ADDENDUM NO. 1

Glenmore Water Resource Recovery (WRRF) Clarifier Coating Project

RFQ No. 1087

Rivanna Sewer & Water Authority

GLENMORE Sewage Treatment Plant Applied Technology and Engineering, P.C. Charlottesville, Virginia		Title: CLARIFIER - STRUCTURAL	
Scale: 20:1	Date: 2/17/92	Drawn By: JCS	Approved: [Signature]
Rev. No.	Description	By	Date

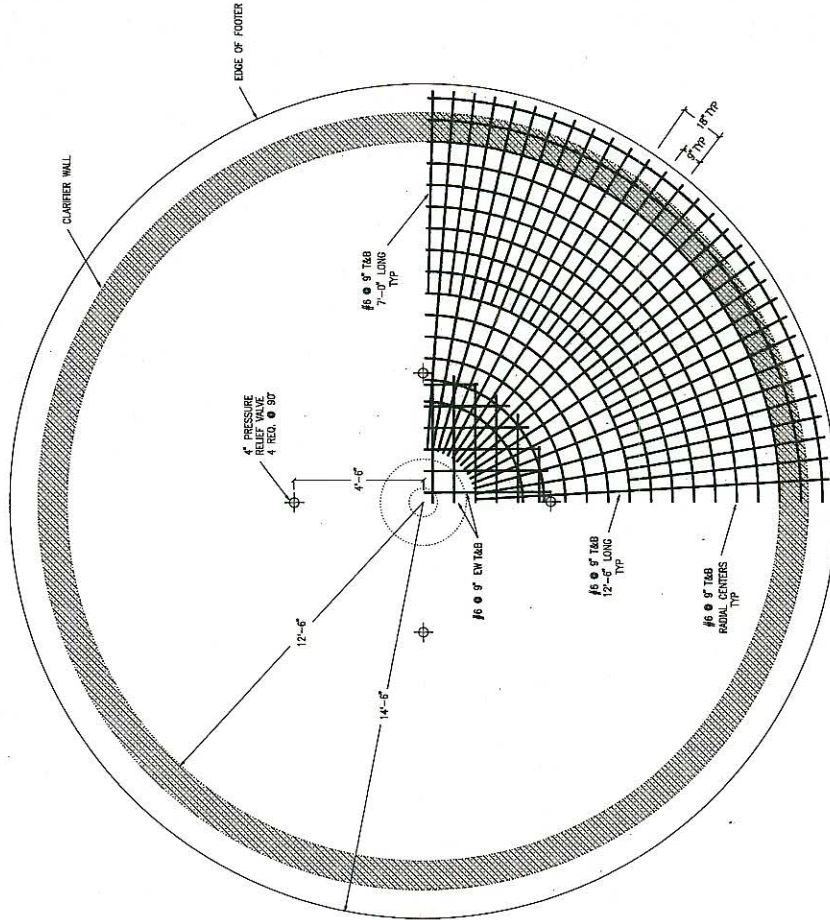
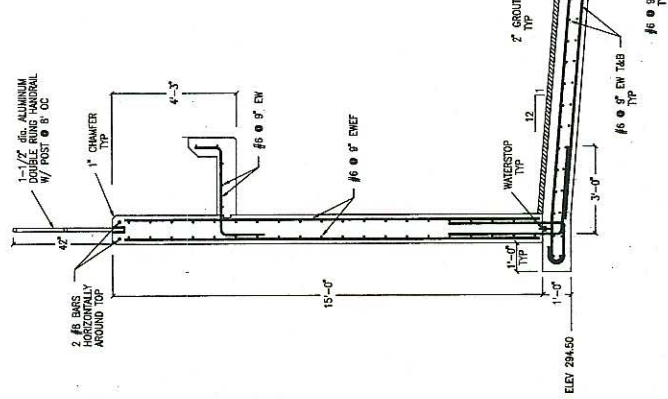
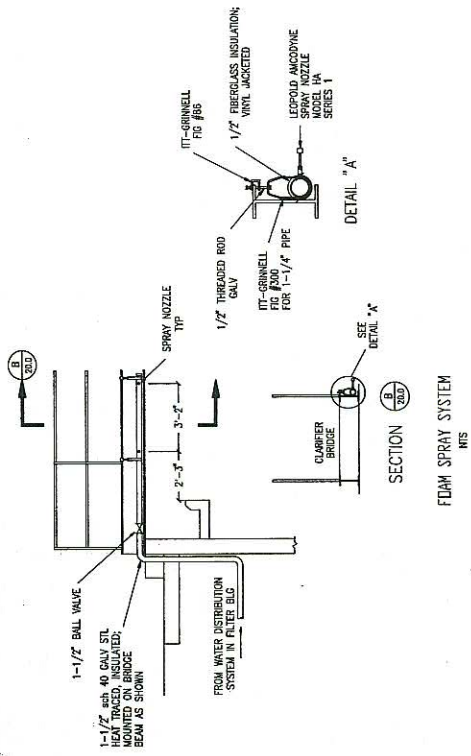
4. Add the attached drawing to Appendix B for general reference, which shows the side wall depth of the clarifiers as approximately 15 feet.
